## RESIDENTIAL MANDATORY MEASURES, SHEET 1

CITY OF MALIBU  
COMMUNITY DEVELOPMENT DEPARTMENT  
PLANNING DIVISION  
SUBSTANTIAL CONFORMANCE  
PLANNING REVIEW NO. PVPF 24-021  
DATE: 6.24.2026  
SIGNATURE: *[Signature]*  
PRINT NAME: Aakash Shah  
THESE PLANS HAVE BEEN REVIEWED AND  
ARE IN CONFORMANCE WITH THE PLANS  
APPROVED ON:

## Fire Rebuild

5911 Bonsall Dr.  
Malibu, CA 90265

N SITE PLAN  
SCALE: 1/32" = 1'-0"

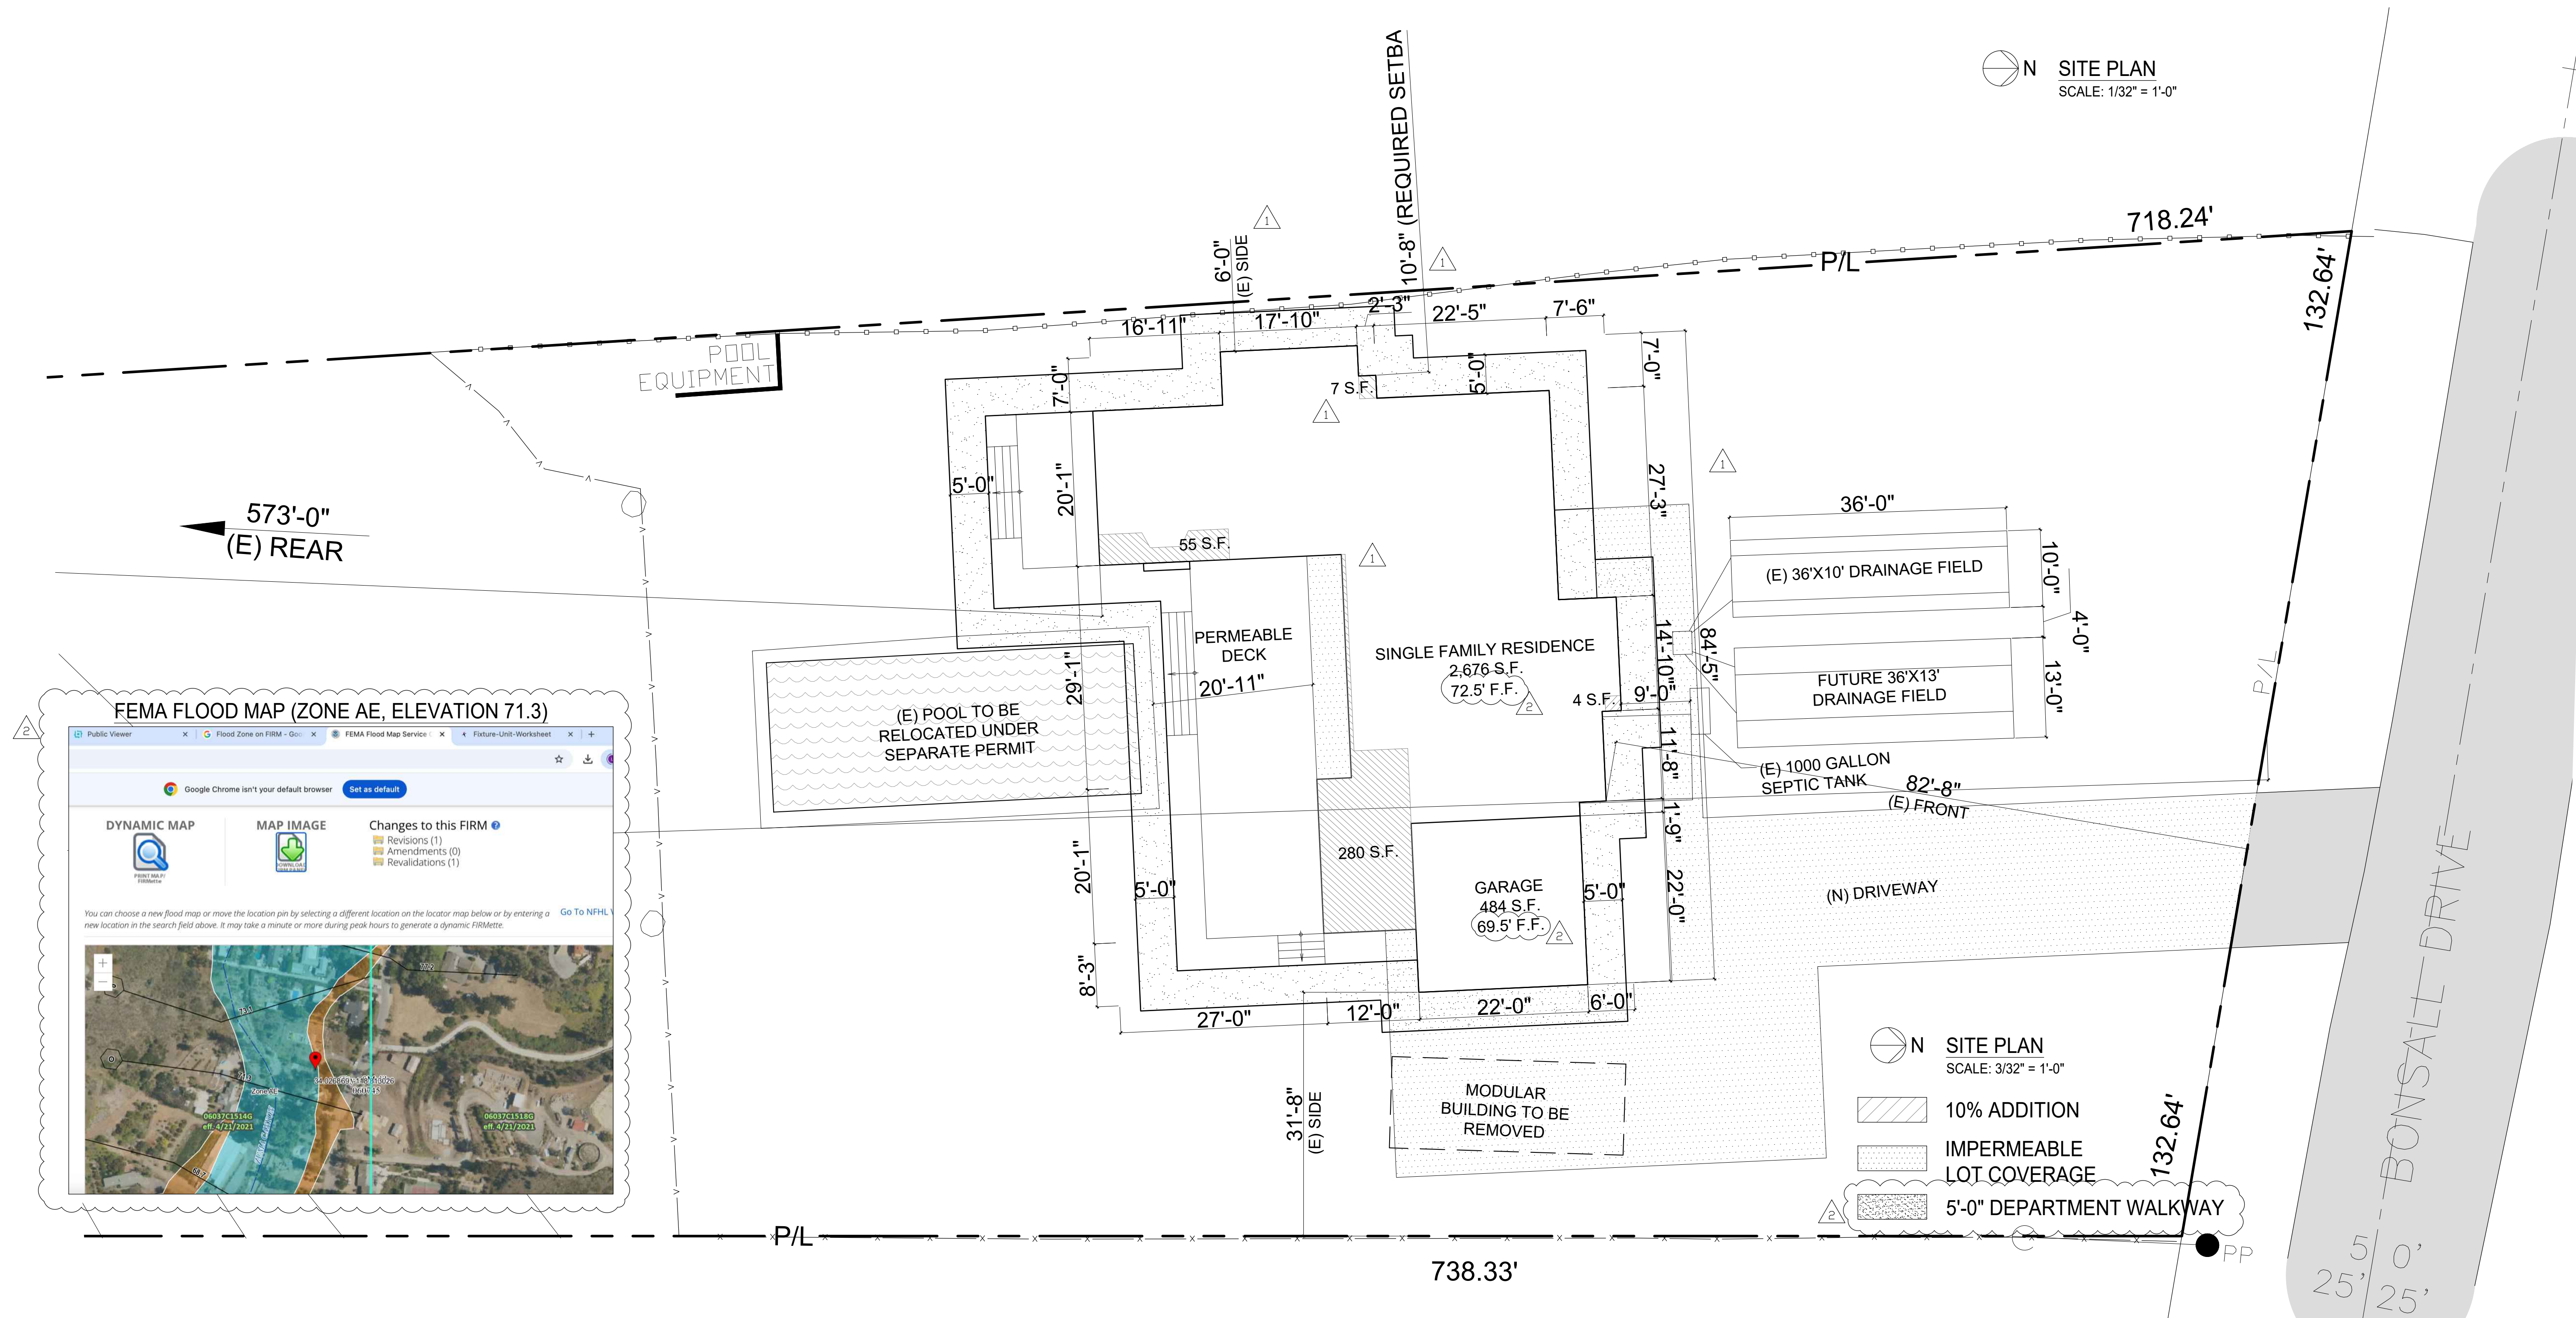
1. Please include the Public Works Department General Notes (see attached) and fill out Notes 19 and 20.
2. This property is located within the FEMA AE Zone and the structure may need to be elevated to be above the base flood elevation. Please provide this information on the plans and show where the proposed structure is in relation to the AE Zone. Confirm that the lowest floor of the proposed structure is 1 foot above the FEMA base flood elevation.

3. Please provide a grading plan or provide existing features and proposed grading improvements on a site plan. Call out/provide construction notes for all proposed grading improvements. Show elevations and slopes.

4. Please provide a drainage plan or provide existing and proposed features of the on-site storm drain system on a site plan. Call out/provide construction notes for all drainage features. Provide drainage flow direction arrows, pipe sizes, invert elevations, and slopes.

5. Please provide the location of down spouts, roof drains, and the connection to the on-site storm drain system.
6. Please provide construction details for all proposed drainage features on site. Features include, but are not limited to, inlets, cleanouts, etc.

7. Prior to the issuance of the Grading/Building permits for the project, please provide a Local Storm Water Pollution Prevention Plan. This plan shall include an Erosion and Sediment Control Plan (ESCP) that includes, but not limited to:
